SERVICE LETTER

No. 596A

Piper Aircraft Corporation

Subject: Nose Landing Gear System Product Advancement Information.

NOSE GEAR STRUT ASSEMBLY

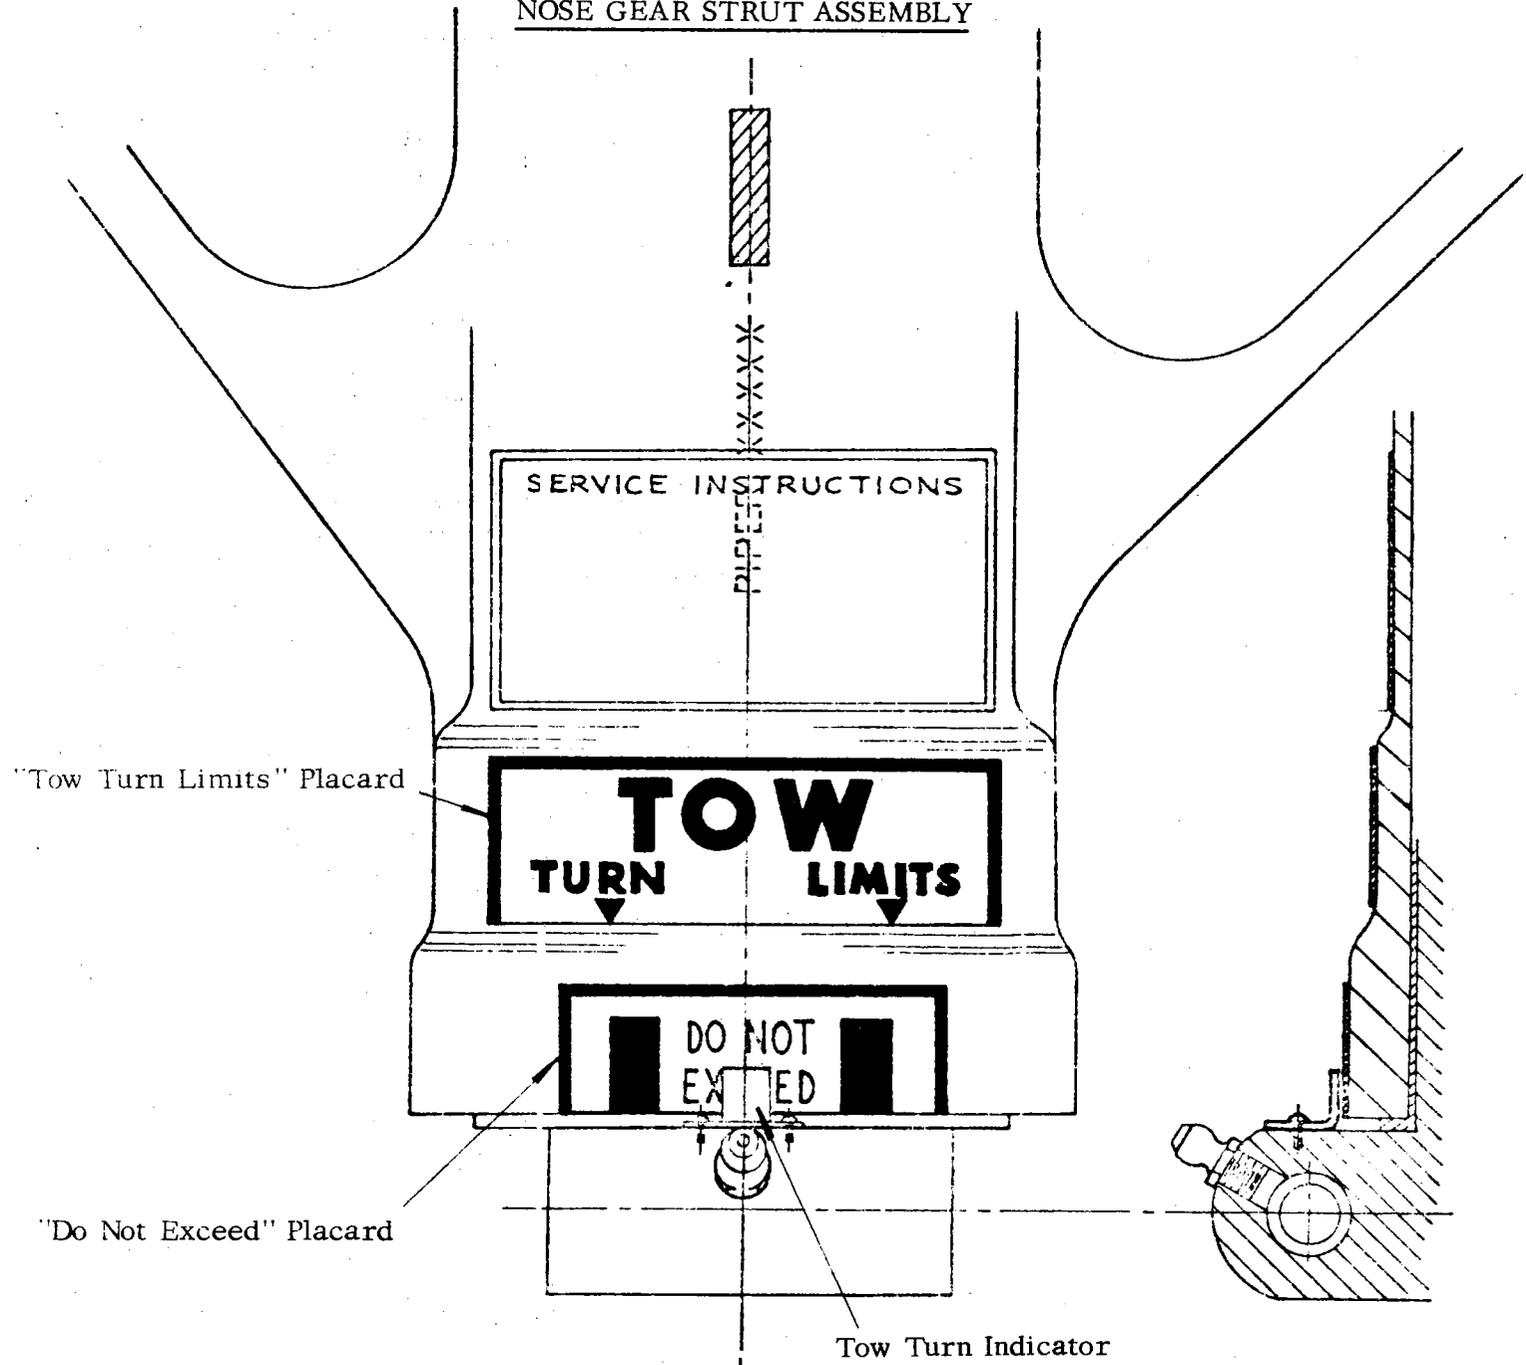
Replace Existing Bolts with High Strength Bolts - P/N 402 800 (NAS 1303-8H) (3 Req'd.) Torque 30-35 in. lbs.

Drill and Ream Holes .202 / .204 Diameter

1. Nose Gear Aligner Guide Bracket Assembly - applies to all aircraft specified in Material Required No. 1, below:
 - a. Inspect existing Nose Gear Aligner Guide Bracket; if guide channel material thickness is .062", replace with new Aligner Guide Bracket Assembly, part number 21719-11. NOTE: It is recommended that the new Aligner Guide Bracket be installed using the new "High Strength" Attachment Bolts, specified below. Prior to installation, check attachment bolt hole size (in Aligner Guide Bracket) to insure .202" diameter, as shown on top portion of attached sketch. .204

- b. If existing Aligner Guide Bracket channel material thickness is .095", remove, ream attachment bolt hole size to .202" diameter (as shown on top portion of attached sketch) .204 and reinstall using new "High Strength" bolts.
